Savage Coal Terminal

**APPENDIX 3-8**

Proposed

Transfer Conveyor Addition

A3-8-2

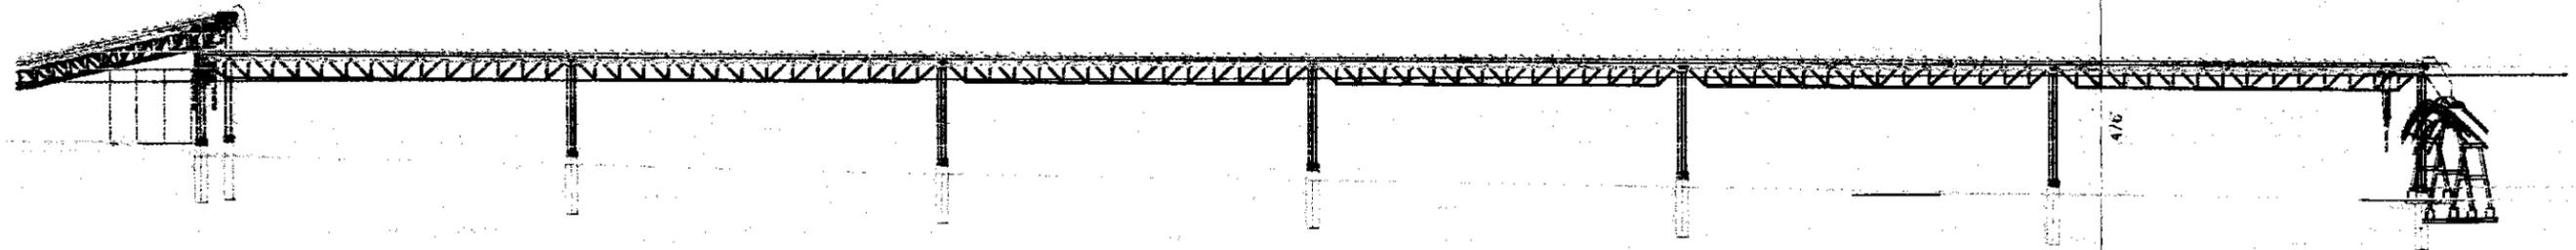
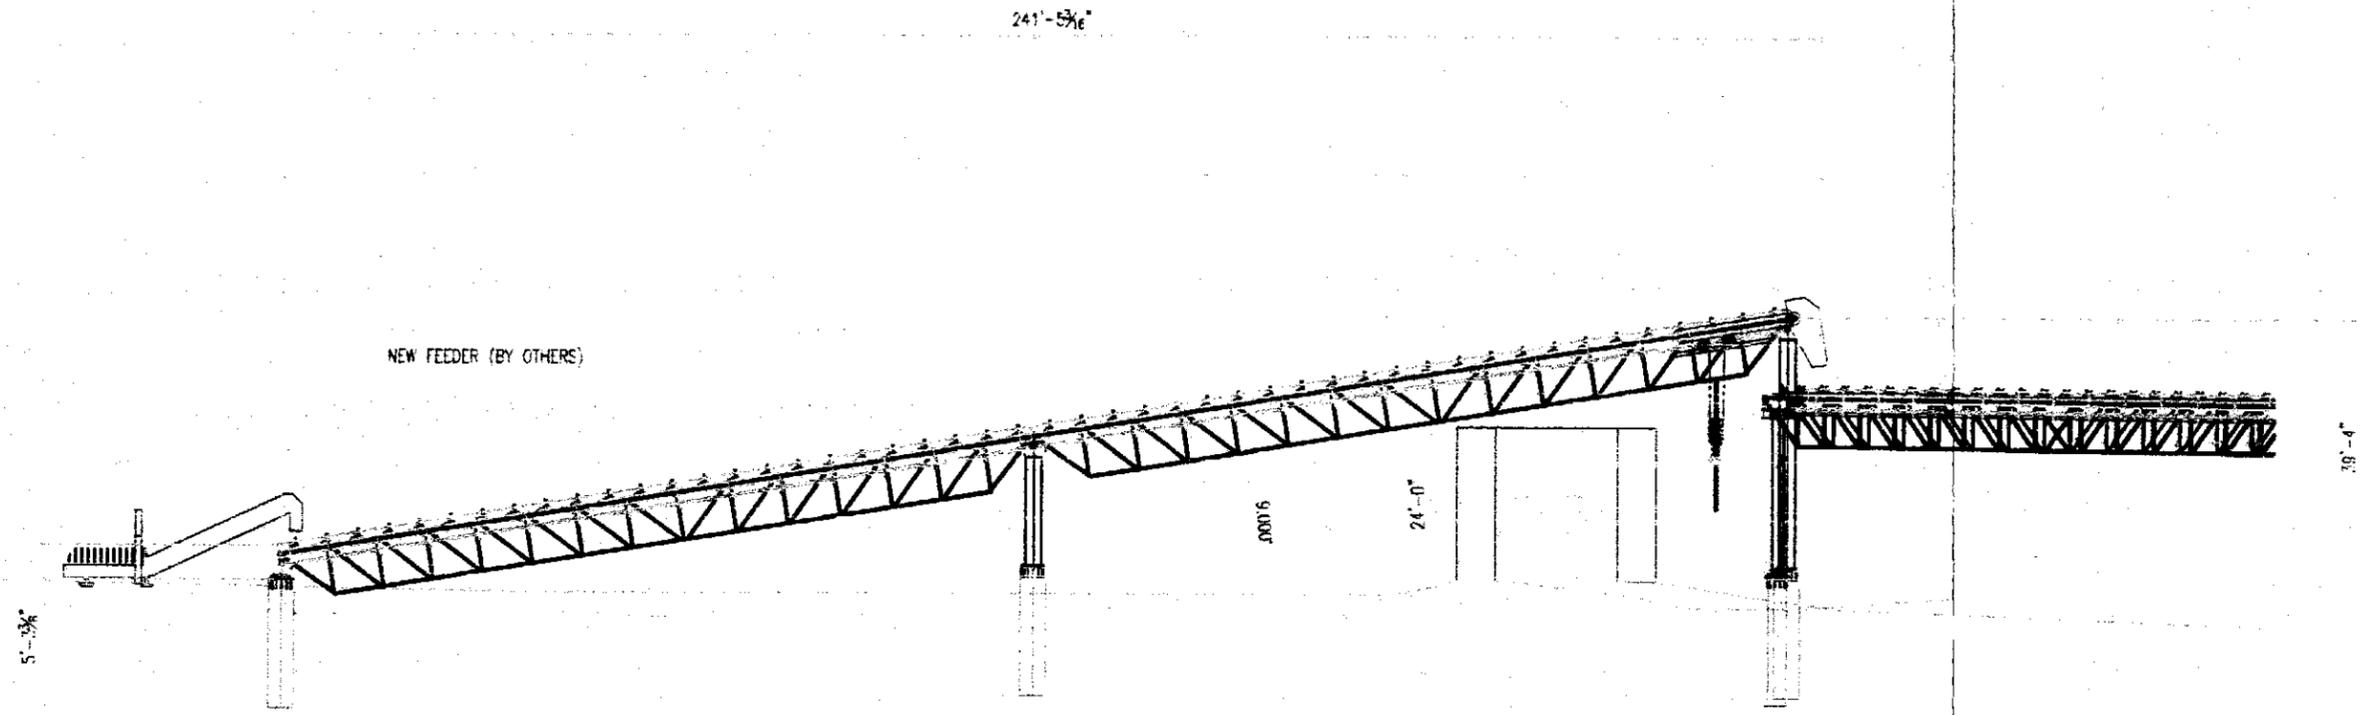
The proposed system consists of 3 conveyors. Two of the conveyors will be elevated, and are approximately 246' and 728' in length, respectively. The third conveyor is a surface transfer system, and is approximately 564' in length. This conveyor is shown as a future installation; however, it is included in this proposal for permitting purposes. Conveyor details are shown on enclosed Plates A3-8-1, A3-8-2, and A3-8-3. All conveyors are 48" wide and will be equipped with covers.
